BURLINGTON DEVELOPMENT REVIEW BOARD

Tuesday, July 20, 2021, 5:00 PM

TO: Development Review Board
FROM: Mary O'Neil, AICP Principal Planner
DATE: July 20, 2021
RE: ZP21-450; 28 Sunset Cliff Road

File: ZP21-450 OG
Location: 28 Sunset Cliff
Zone: RL-W **Ward:** 4N
Parking District: Neighborhood
Date application accepted: May 22, 2021
Revised plan received: July 12, 2021
Applicant/ Owner: Maxx Garrison
Request: Demolish existing single family home; build new single family home with associated site improvements. A detached garage is proposed with an Accessory Dwelling Unit.

Proposed
Site Plan

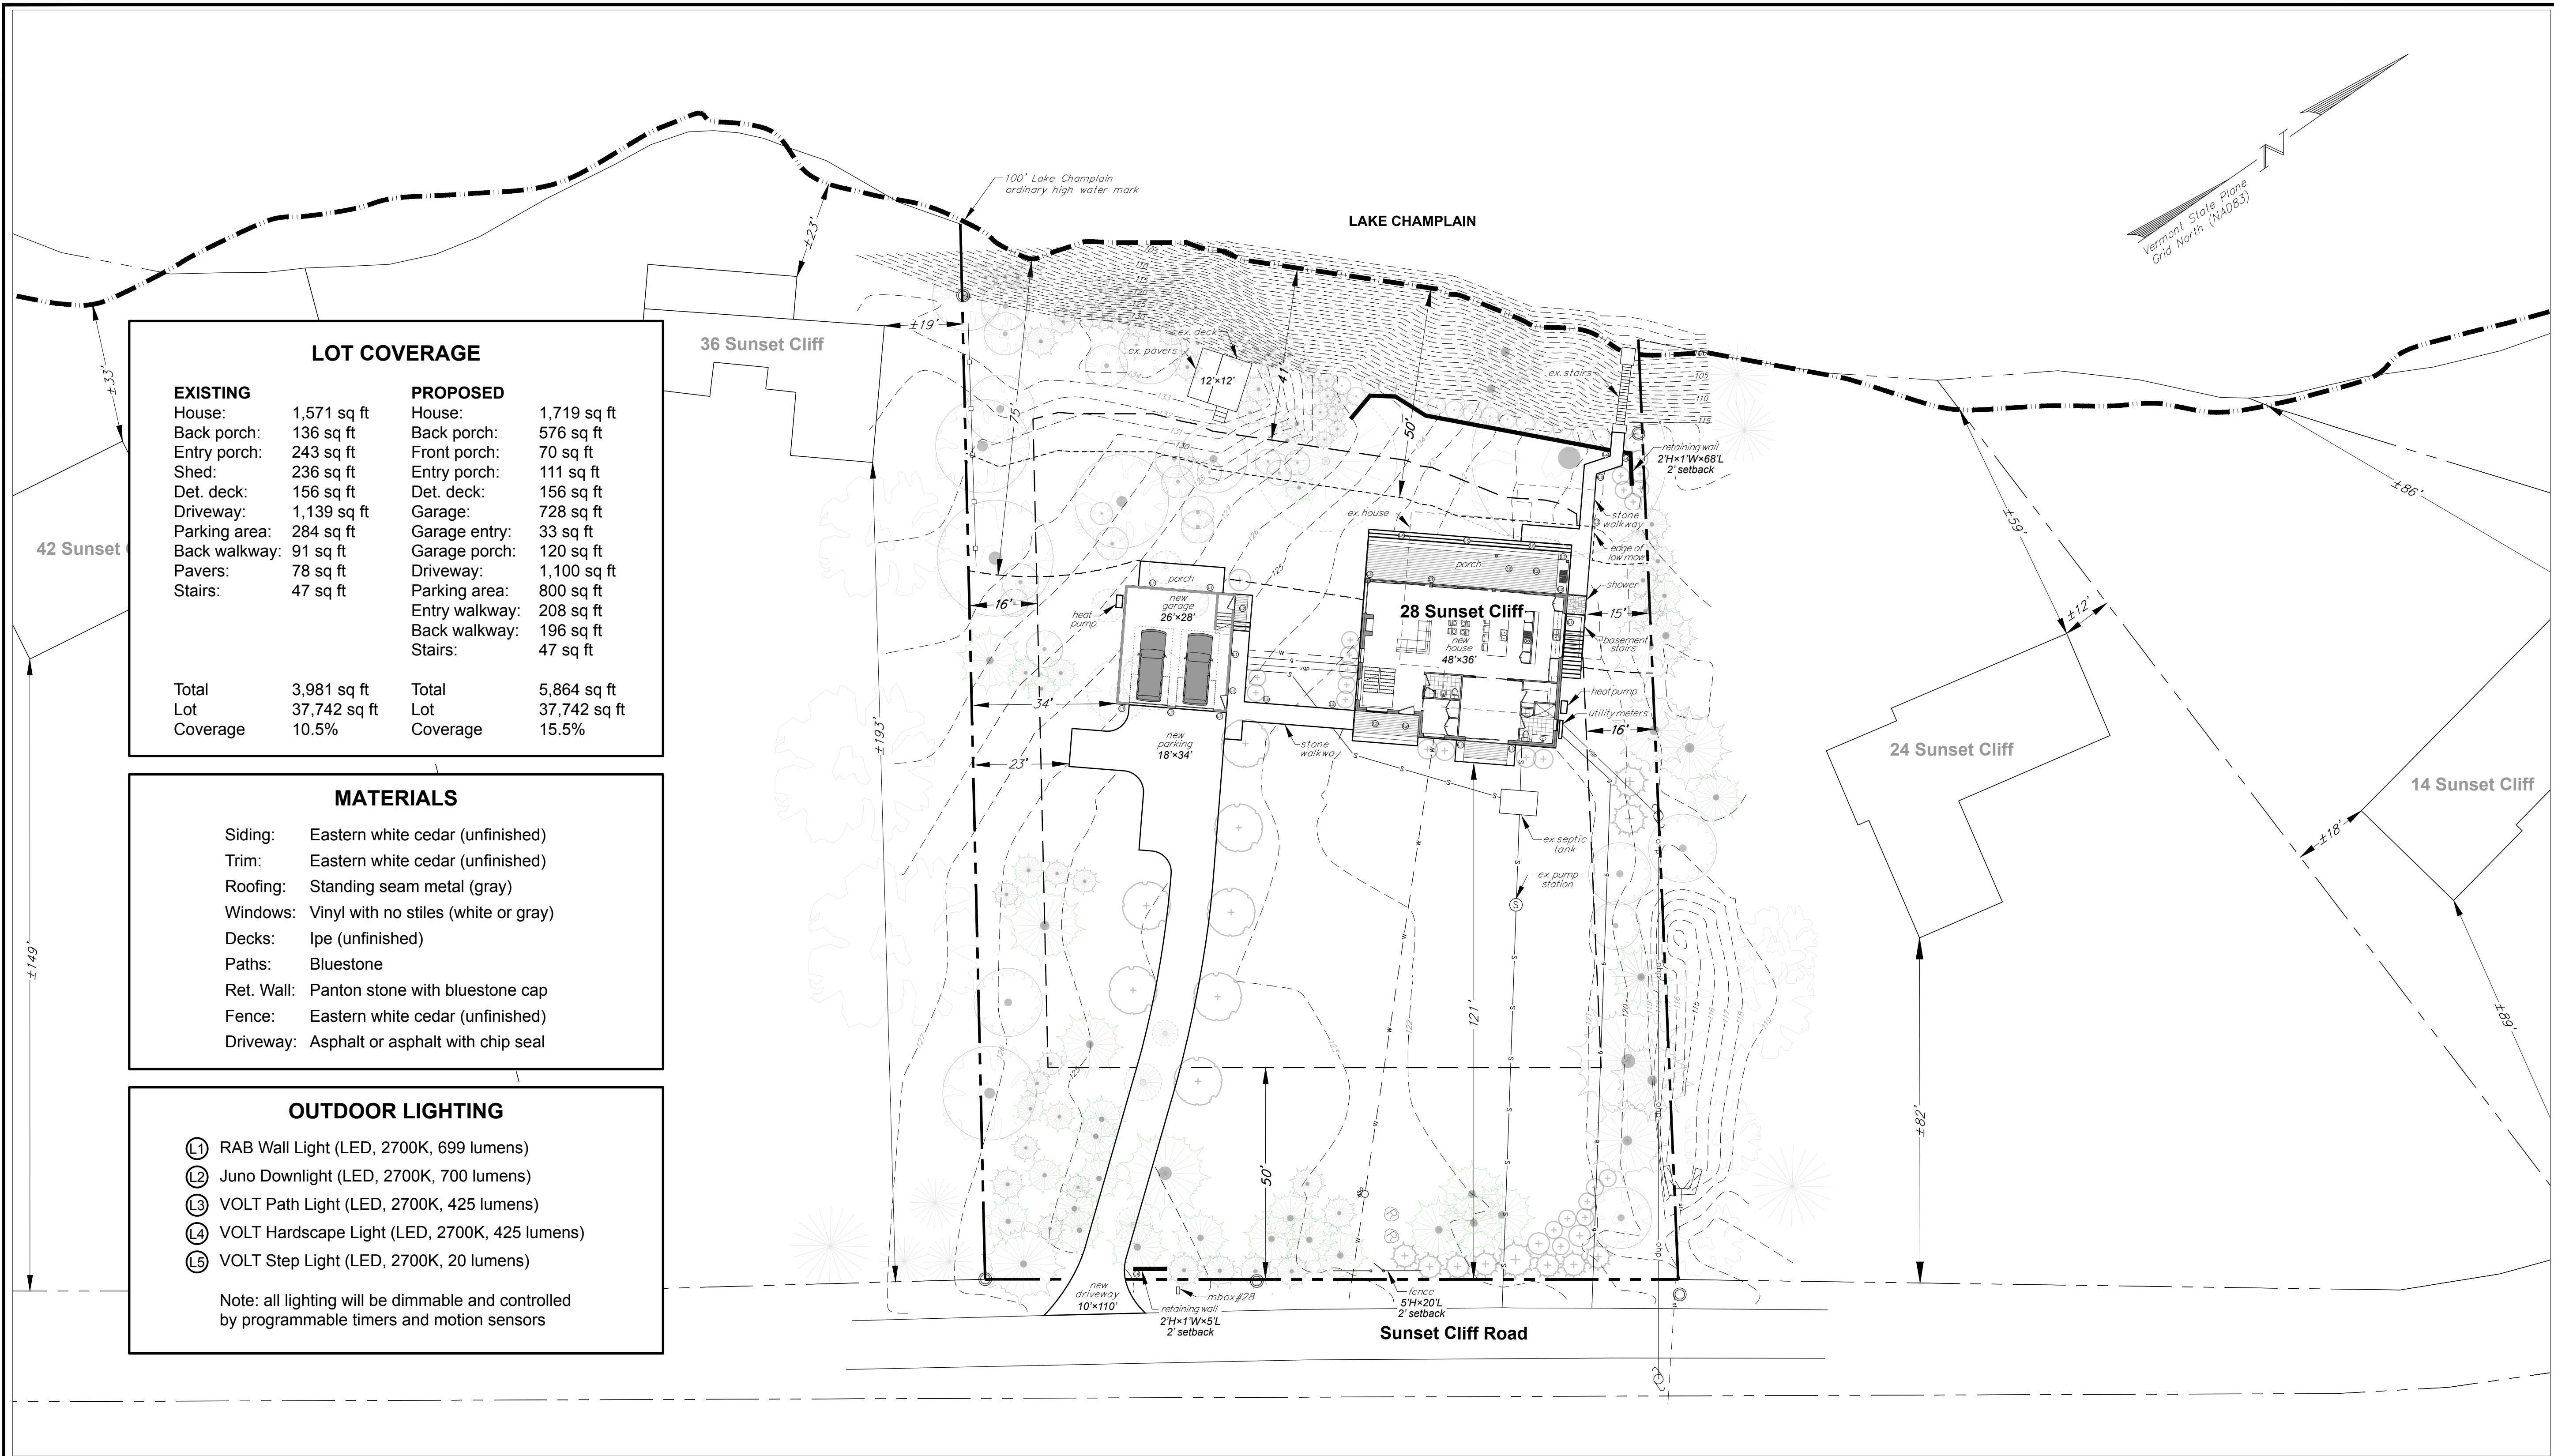
The average waterfront setback of adjacent principal structures is 41 ft. The application proposes a waterfront setback a little more than 50'. See Plan C-3.0 as revised.

The site slopes gradually from east to west, toward the lake. Aside from construction disturbance, the existing topography appears to remain unchanged. A 2' x 12"x 68' long retaining wall is proposed west of the new home. Plan C-3.0 defines the retaining wall as Panton stone with bluestone cap. **Affirmative finding.**

Waterfront setbacks can be based on the average of two adjacent parcels, averaging only 36 and 24 Sunset Cliff Road. From this measurements (59' and 23"), the waterfront setback average is 41'. The site plan has been corrected to reflect this.

The driveway is proposed to be relocated south of its existing location. Plan C3.0 defines the driveway as asphalt or asphalt with chip seal.

A 5' high cedar fence is identified on Plan C-3.0, This shall not encroach within the Clear Site Triangle (see image, above), and shall present a finished side to the street. **Affirmative finding as conditioned.**

A heat pump/recovery unit is proposed along the northerly elevation of the principal residence, and at the southerly elevation of the garage/ADU. Meters and mailbox locations have been identified on plan C3-0.

Drawing Title
**Proposed
Landscape Plan**

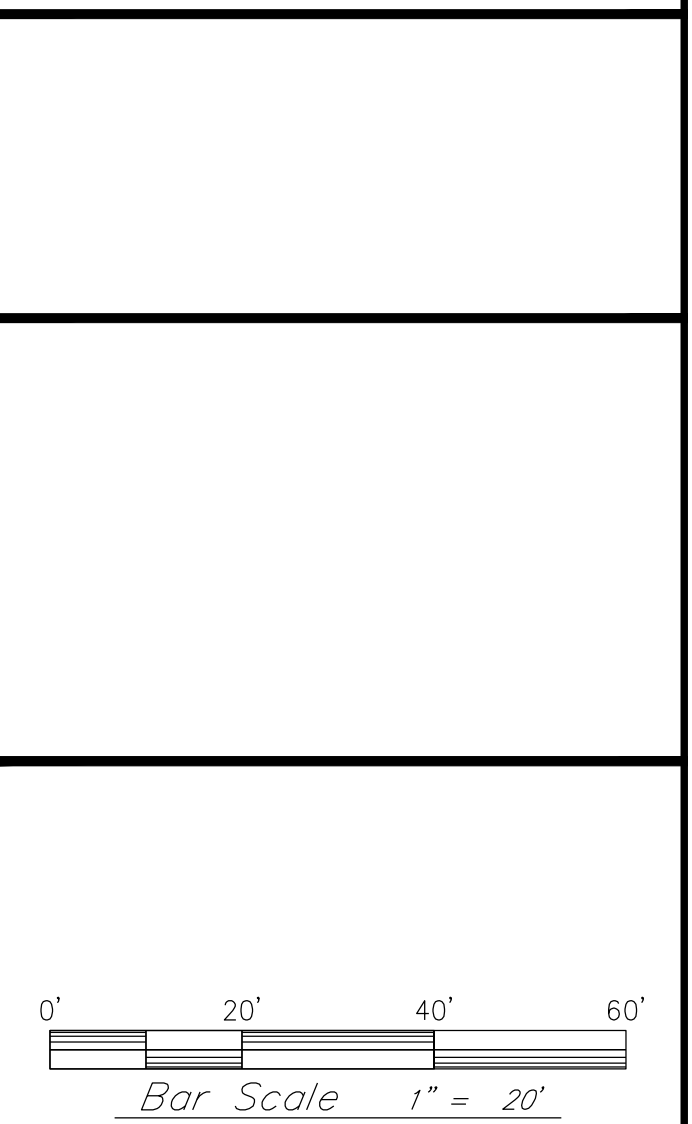
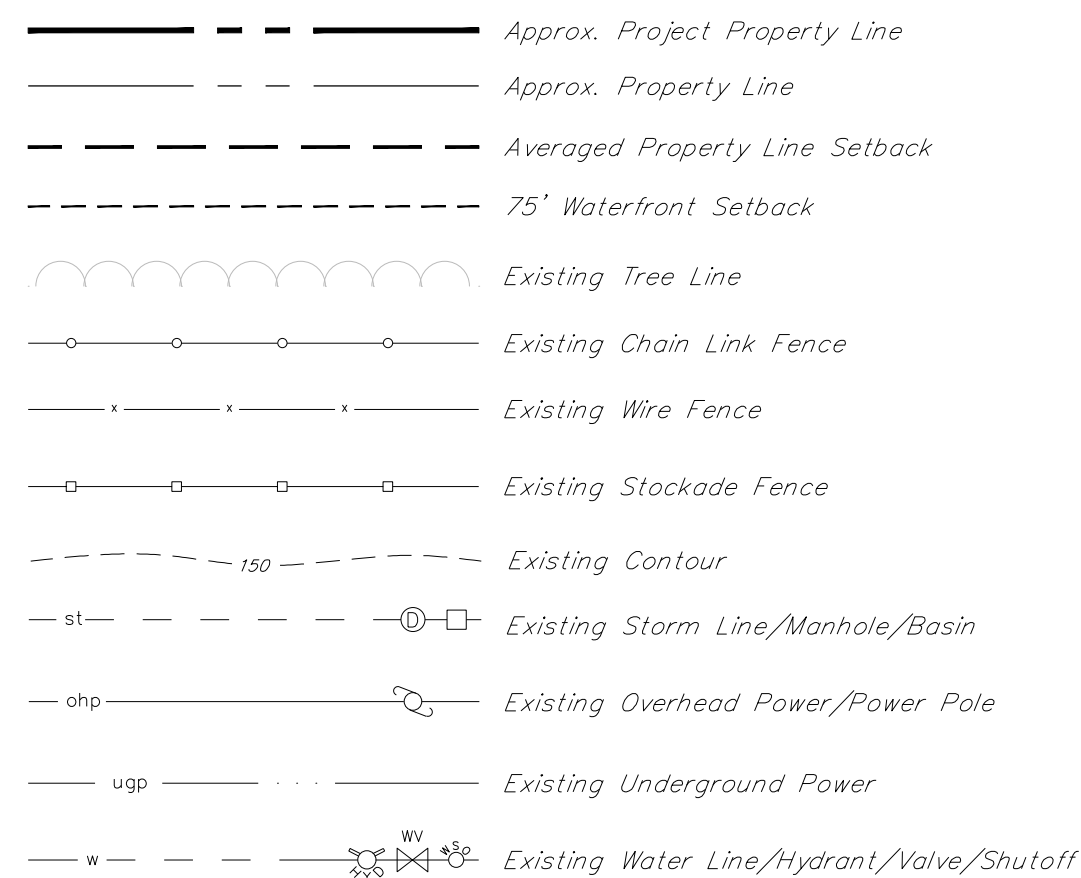
The required low-mow zone has been identified on Plan C-4.0. (see "Planting Schedule.") and Plan C-3.0. **Affirmative finding.**

The submitted landscaping plan (C-4.0) shows a plan focused on the northerly boundary, and around the perimeter of the lot. Mixed evergreen and native shrubs with native ground cover are the choices, with an allée of Maples along the driveway. The Clear Site Triangle will all be observed at the driveway entrance to provide safe sight distances for both pedestrians and vehicles.
